DART AEROSPACE LTD		Work Order:	87558
Description: Crosstube Assembly (205/212/412 High Fwd)		Part Number:	D212-664-141
Inspection Dwg: D212-664-141 Rev: D		Page 1 of 2

DESIGN	PH	DART AEROSPACE LTD HAWKESBURY, ONTARIO, CANADA	
DRAWN	RF		
CHECKED	9	DRAWING NO.	REV. D
MFG. APPR.	18	D212-664-141	SHEET 2 OF 4
APPROVED	18	TITLE	SCALE
DE APPR.	18	XTUBE ASS'Y (205/212/412 HI FWD)	NTS
DATE	09.09.30	COPYRIGHT © 2000 BY DART AEROSPACE LTD THIS DOCUMENT IS PRIVATE AND CONFIDENTIAL AND IS SUPPLIED ON THE EXPRESS CONDITION THAT IT IS NOT TO BE USED FOR ANY PURPOSE OR COMMUNICATED TO ANY OTHER PERSON WITHOUT WRITTEN PERMISSION FROM DART AEROSPACE LTD.

DRAWING NO. D212-664-141	TITLE XTUBE ASSY (205/212/412 HI FWD)	REV. D	DART AEROSPACE LTD ENGINEERING ORDER		D.E.O. NO. D212-664-141-D-1	SHEET NO. SHEET 1 OF 2	SCALE NTS
DRAWN	CHECKED	MP	MFG. APPR.	EE	APPROVED	MP	DE APPR.
DATE 11.04.07	DATE 11.07.11		DATE 11.04.12		DATE 11/04/12		DATE 11.04.12

DRAWING NO. D212-664-141	TITLE CROSSTUBE ASS'Y (205 HI FWD)	REV. D	DART AEROSPACE LTD ENGINEERING ORDER		D.E.O. NO. D212-664-141-D-2	SHEET NO. SHEET 1 OF 1	SCALE NTS
DRAWN <i>UP</i>	CHECKED <i>ASS</i>	MFG. APPR. <i>AB</i>	APPROVED <i>MD</i>		DE APPR. <i>TH<

D212-664-141/-141B
ASSEMBLY DETAIL

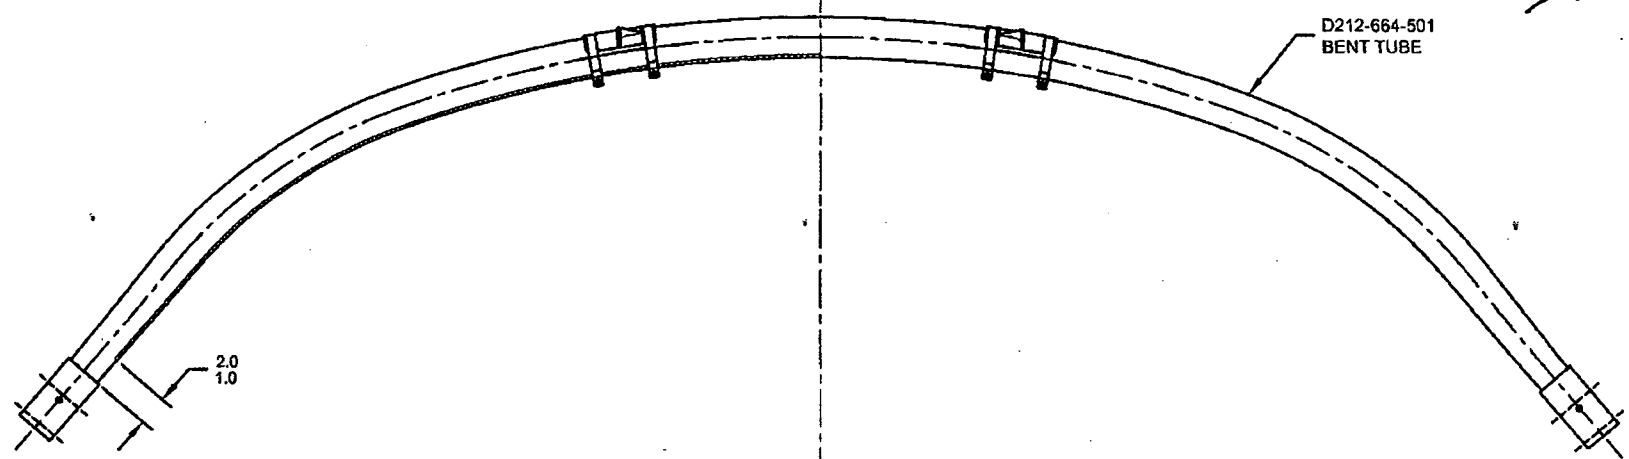
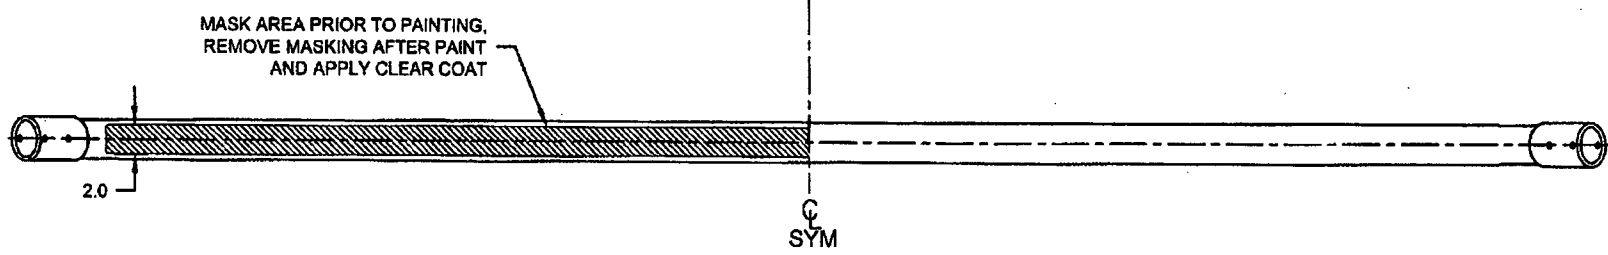
PURPOSE:

ADD AN INSPECTION WINDOW TO UNDERSIDE OF CROSSTUBE.

NOTES 2 OF SHEET 1 IS AMENDED AS FOLLOWS:

IS:

WAS:

- 2) FINISH: CHEMICAL CONVERSION COAT PER DART QSI 005 4.1
PRIME INSIDE AND OUTSIDE PER DART QSI 005 4.2
MASK UNDERSIDE OF CROSSTUBE AS SHOWN (HATCHED AREA) AND
PAINT OUTSIDE PER DART QSI 005 4.2
REMOVE MASKING AND APPLY CLEAR COAT

- 2) FINISH: CHEMICAL CONVERSION COAT PER DART QSI 005 4.1
PRIME INSIDE AND OUTSIDE PER DART QSI 005 4.2
PAINT OUTSIDE PER DART QSI 005 4.2
